# **Service Bulletin**

Subject: RM250/370 OIL RECOMMENDATION  
REFERENCE: Service Bulletin RM-2

Bulletin No: RM-8

Subject: RM250/370 SET UP INFORMATION

Subject: RM250/RM370 REAR FUEL TANK CUSHION  
MODIFICATION

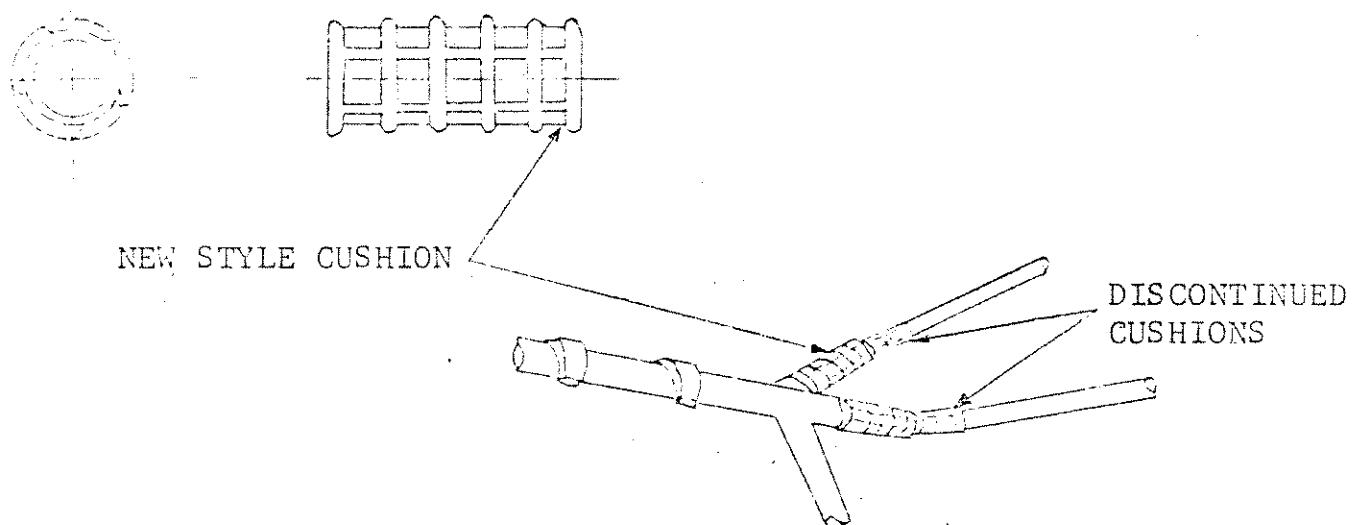
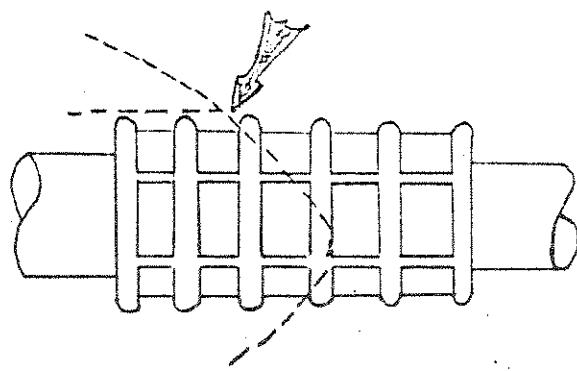
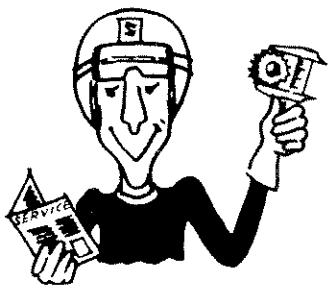
We have received information that RM250 aluminum alloy fuel tanks may become unnecessarily worn at their inner rear portion. This has been found to be caused by allowing the rear fuel tank cushion to become excessively worn.

RM250's on and from Frame Number 11122 have had the use of the most rearward fuel tank cushions discontinued. At the same time, the "new" most rearward cushions (44511-15201) have had their dimensions increased and five horizontal ribs added.

2. Attach new fuel tank cushions to the frame with an epoxy or adhesive cement.
3. Also, when attaching new cushions, position them so that the rear of the fuel tank contacts the third vertical rib as shown below:

1. The fuel tank cushions should be checked after each race and replaced if worn. Regular replacement of these cushions will prevent unnecessary wearing of the RM alloy fuel tank.

This bulletin is issued to advise your Service Department as to the differences in setting the ignition timing on the RM100 and RM125.

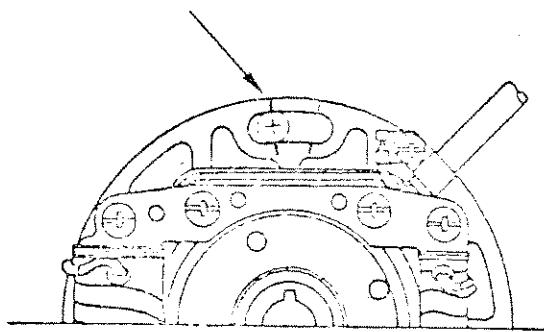
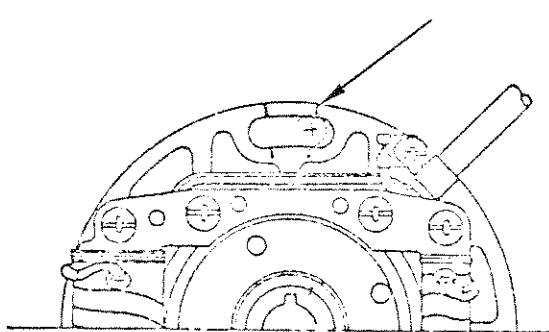
Although the component parts used on each model are identical, the correct positioning of the stator plate is different. This is due to the difference in ignition timing requirements;  $22^\circ$  at 6,000 rpm for the RM100 and  $29^\circ$  at 6,000 rpm for the RM125.

Therefore, the stator plate's top mounting hole has two punch marks for alignment with the crankcase holes center. The left one is for RM125's and the right one is for RM100's as illustrated.

For optimum performance, be sure the correct mark is used for alignment on the appropriate model.

Subject: RM125 KICK STARTER DRIVE GEAR

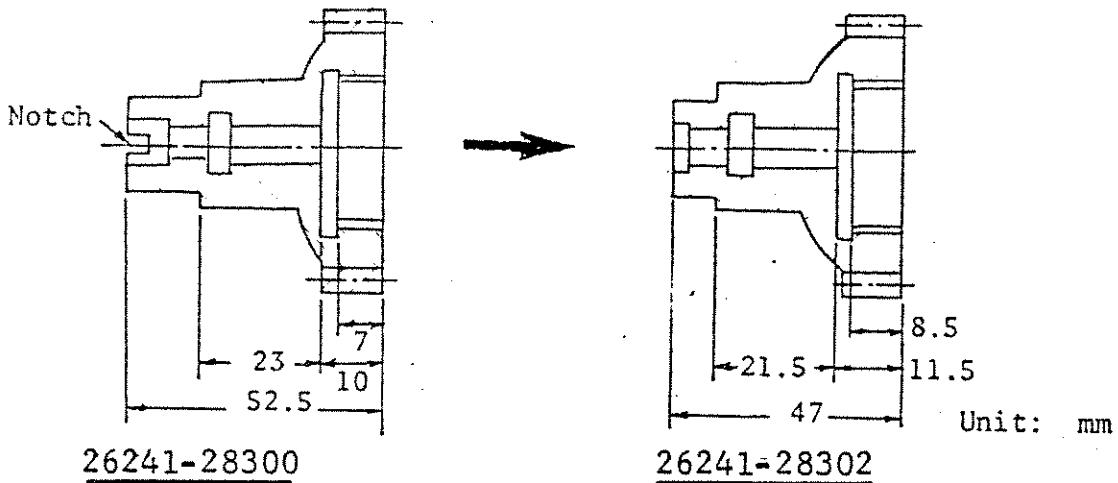
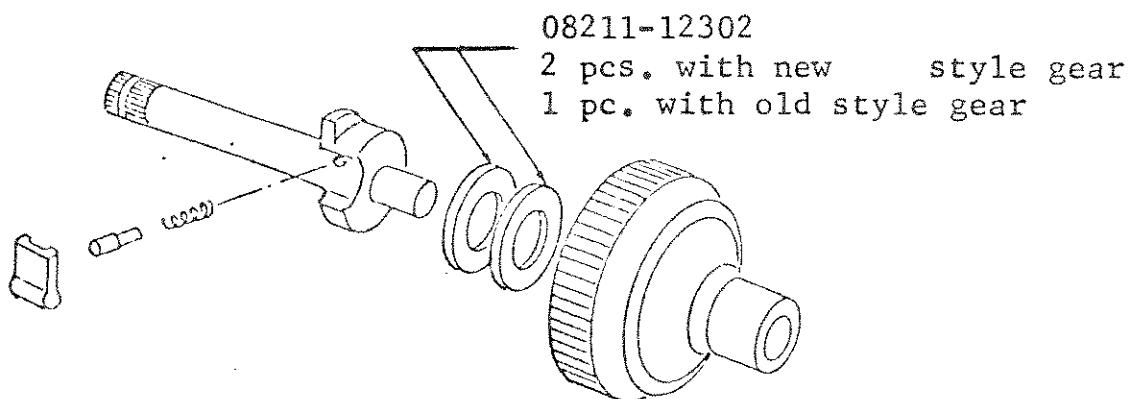
To increase it's durability, the RM125 kick starter drive gear pawl contact surface has been widened 1.5mm. At the same time, a 1.5mm thrust washer has been added to the existing one. Also, the oil pump drive notch has been eliminated, shortening the overall length of the gear.

The old and new style kick starter drive gears are interchangeable. When replacing an old style kick starter drive gear with a new style, be sure to use two thrust washers (08211-12302) inside the

gear for proper spacing of the kick starter shaft.
